TECHNICAL ADDENDUM

Addendum No. 01

**Expansion and Redevelopment of the
North Portal Port of Entry
North Portal, Saskatchewan**

Sheet **ASK-01**

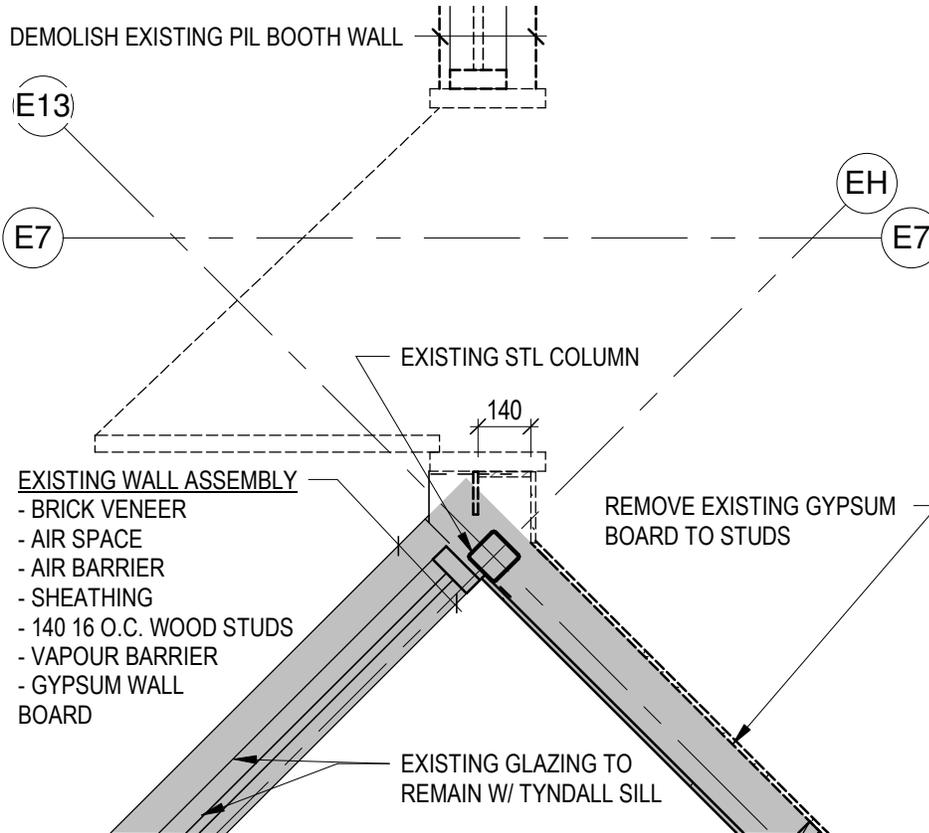
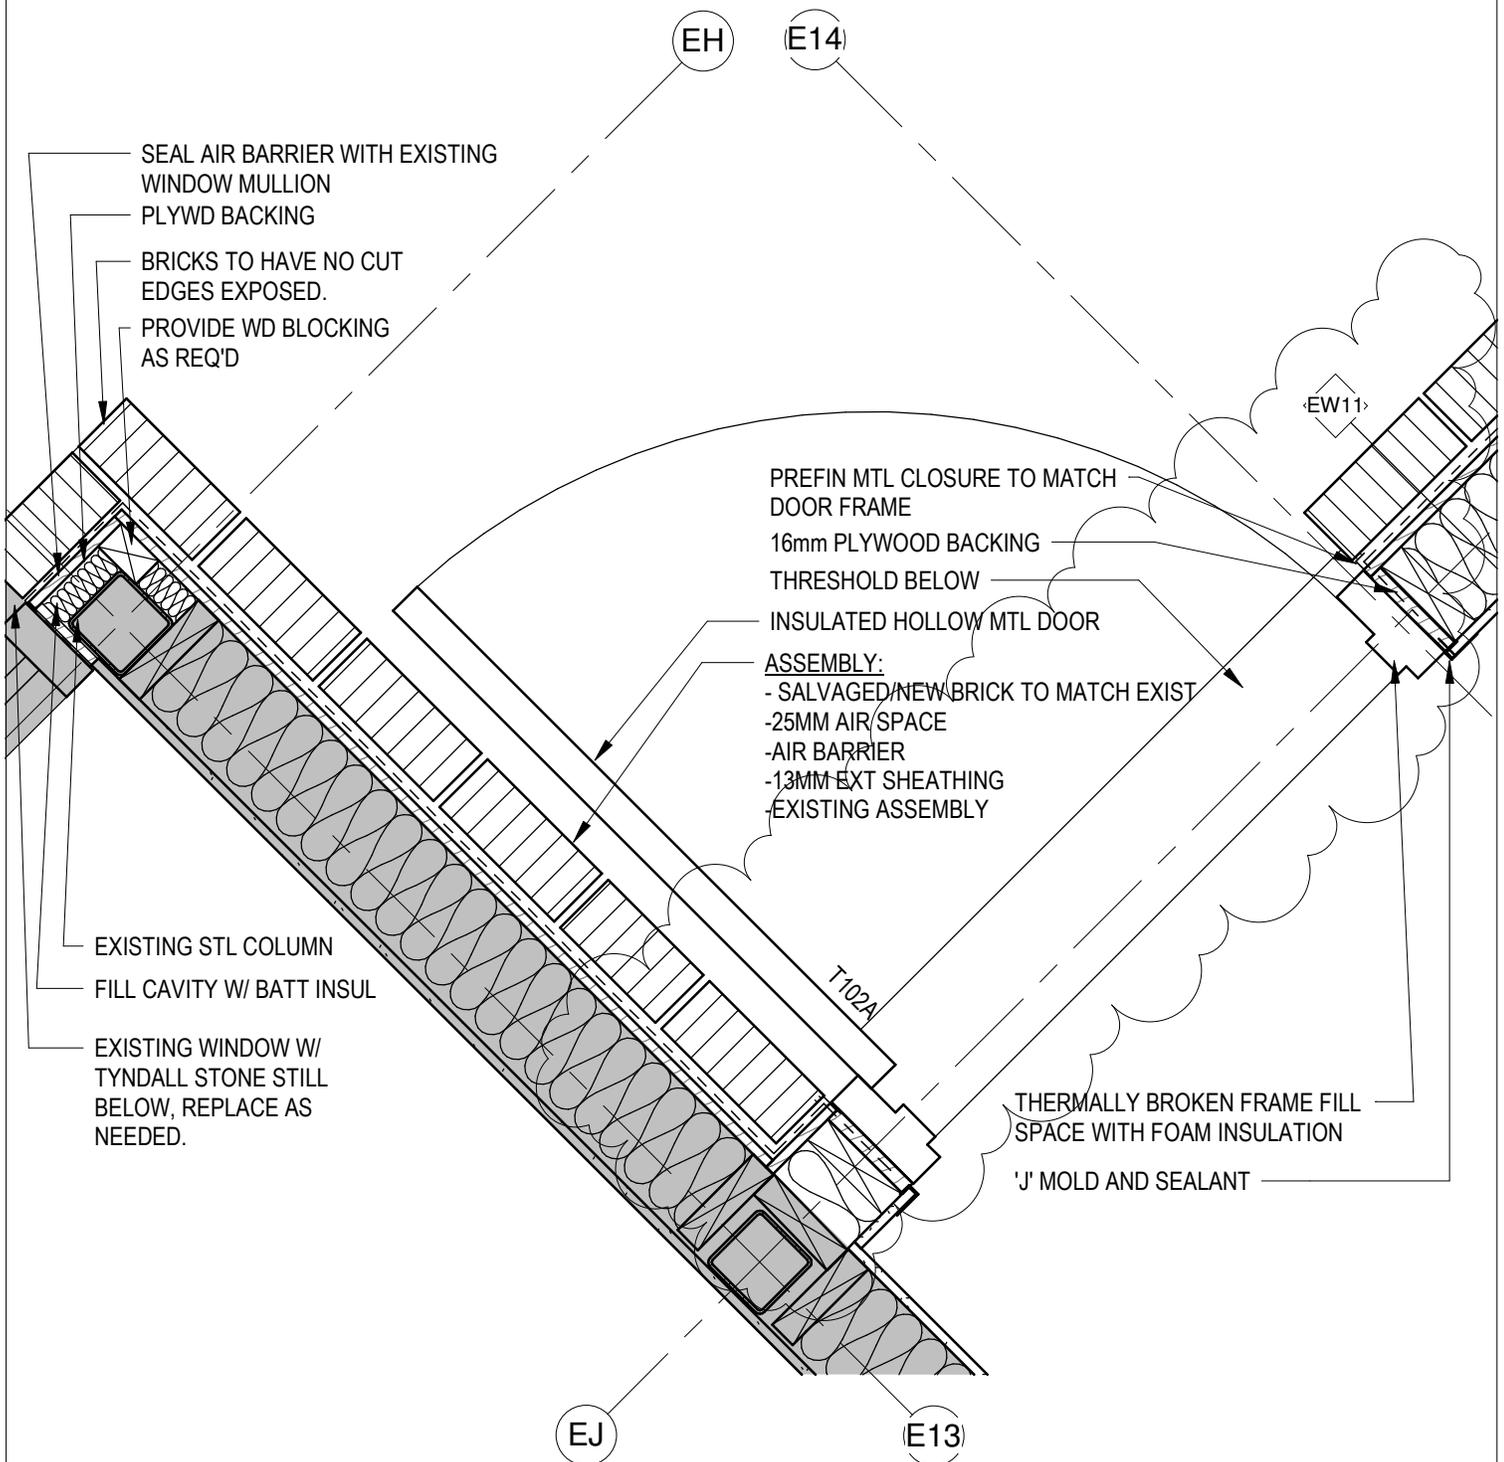
- b. Camera pole supporting camera CE-35 is to be deleted and camera turned over to owner. Refer to sketch ASK-05
4. Refer to Drawing A1.3
 - a. Wall shown enclosing existing room 102 does not currently exist and will be a new wall. Refer to attached ASK -01 and ASK-02

ASK-03

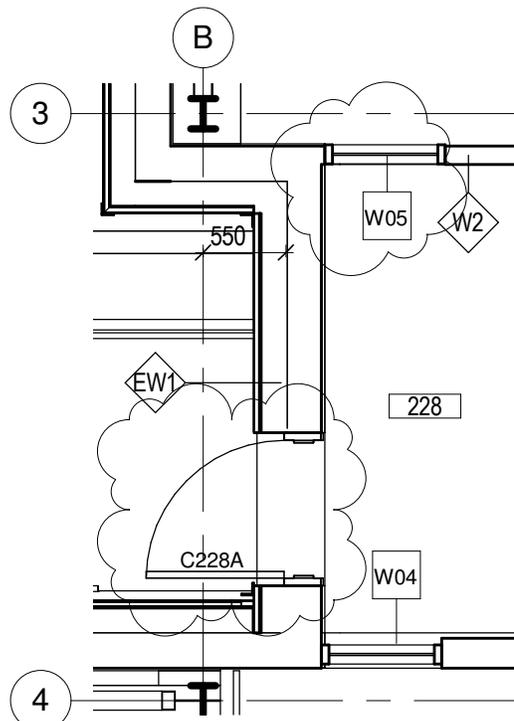
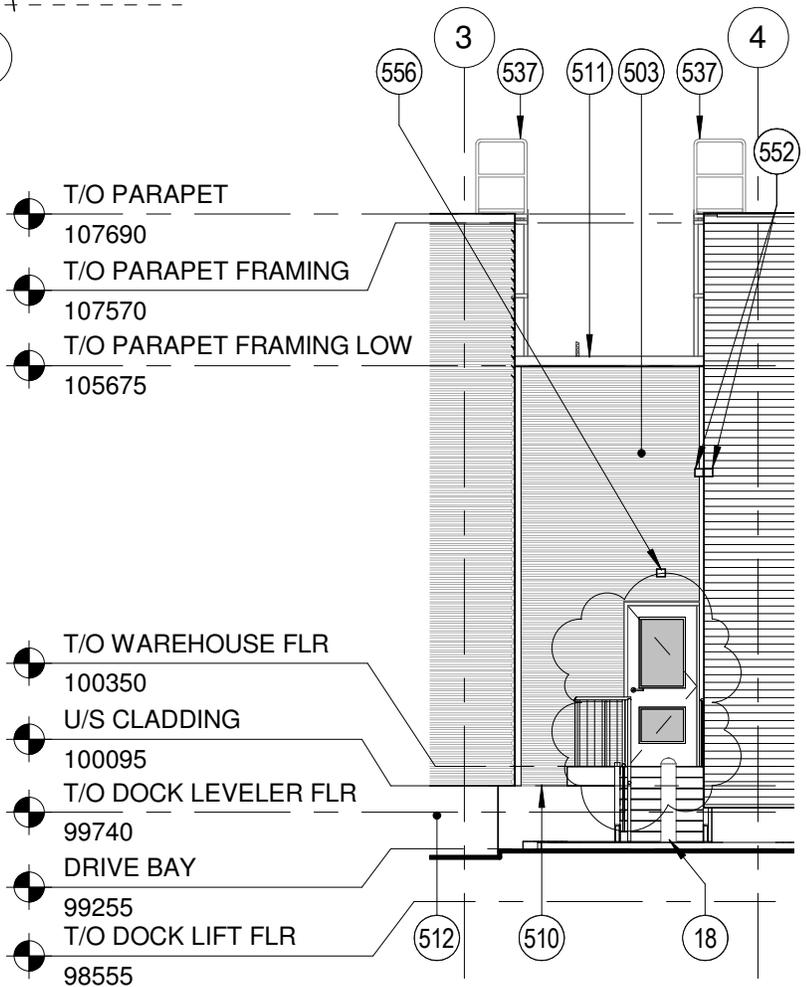
- a. Exterior door D228 into room 228 is not shown on the plans or exterior building elevations. Refer to ASK-03 for door location. Door D228 is correctly indicated on the door schedule.

1 TEMPORARY PRIMARY INSPECTION LANE
ASK-04 1 : 100

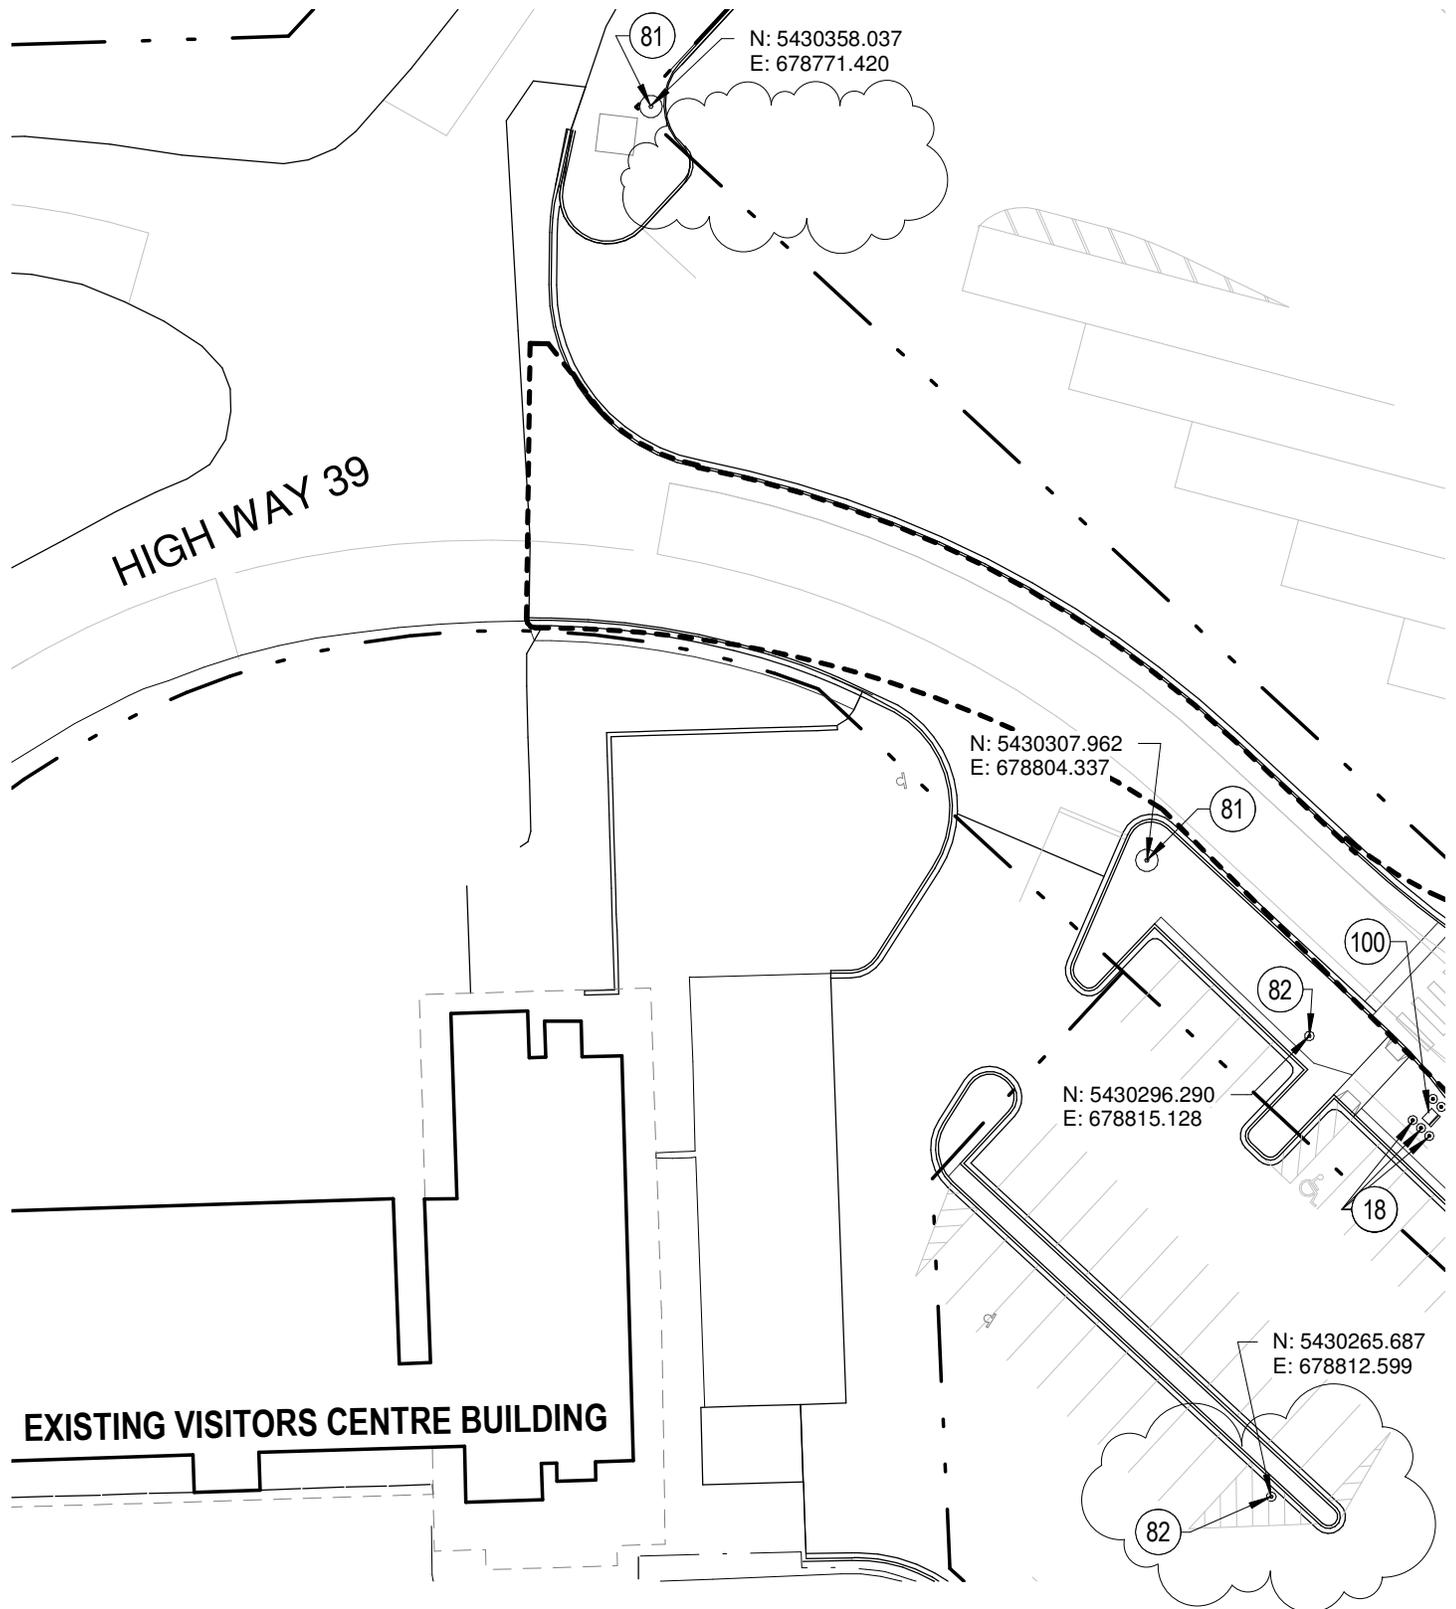
- b. A non-fixed bench is to be provided in room 220. Refer to revised specification below.
6. Refer to Drawing A1.8:
 - a. Temporary PILs shall be revised per attached ASK-04.

1 LIGHT AND CAMERA POLE LOCATIONS
ASK-05 1 : 500

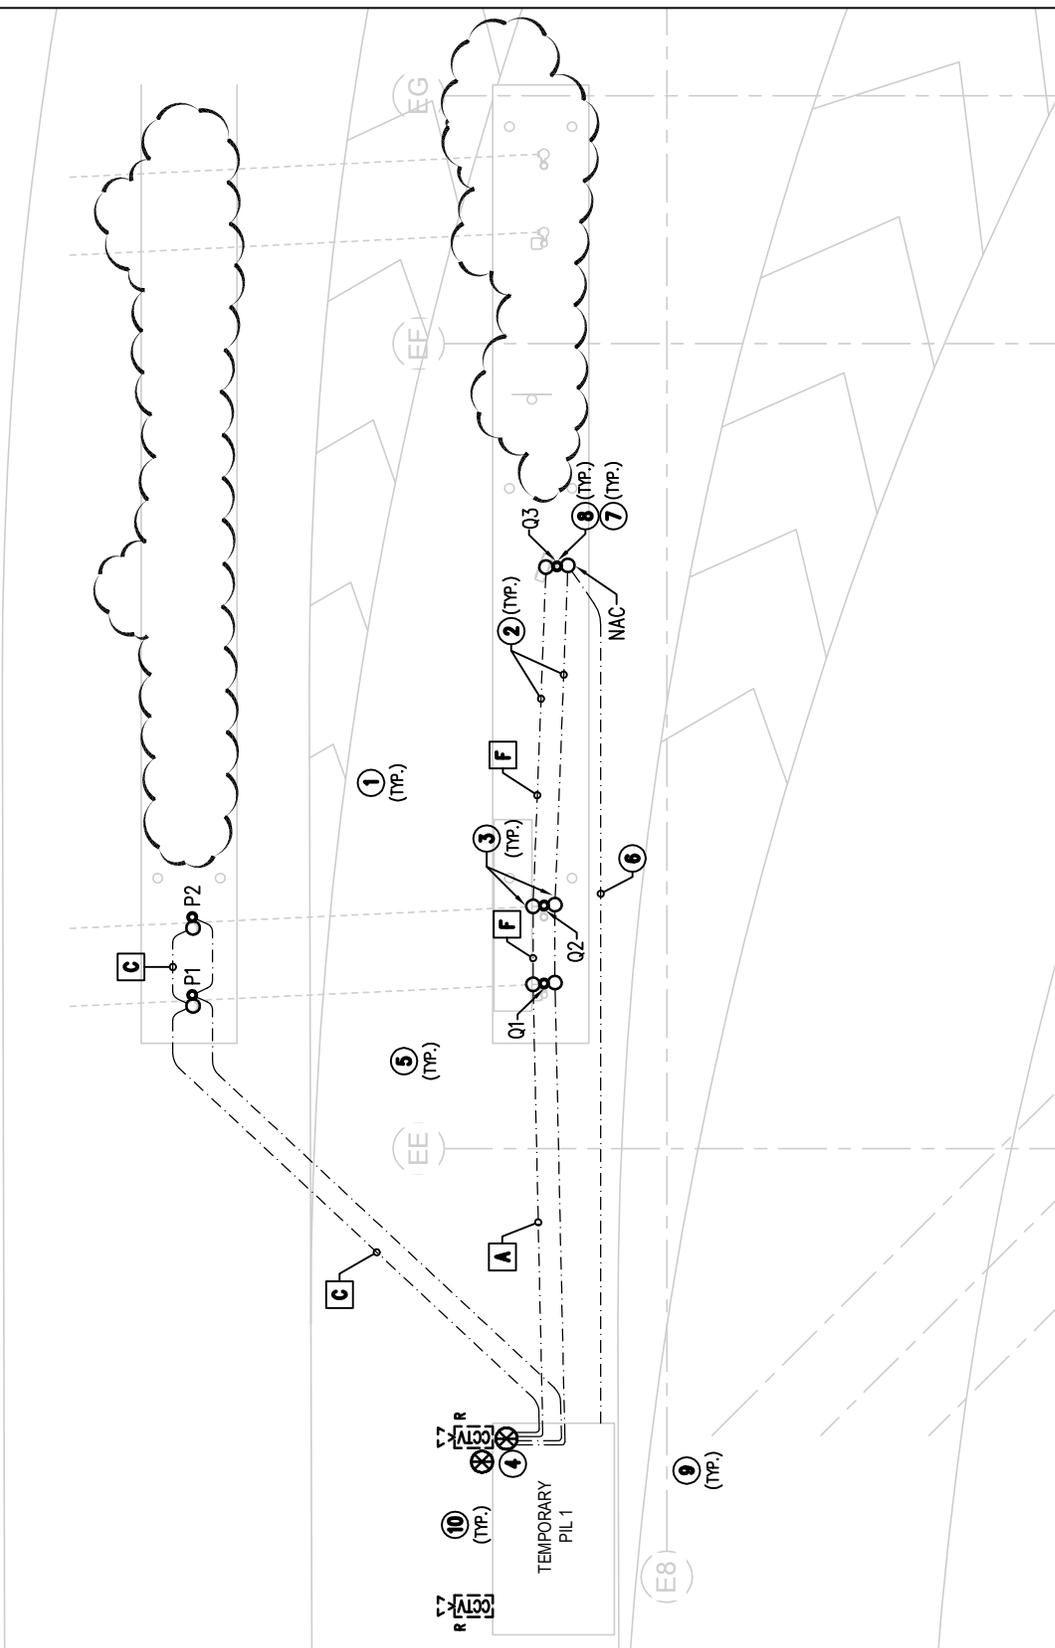
3. Refer to Drawing A1.1 and EC1.1:
 - a. Camera pole supporting camera CE-18 (shown on Electrical drawing) is to be relocated to position indicated on attached sketch ASK-05.
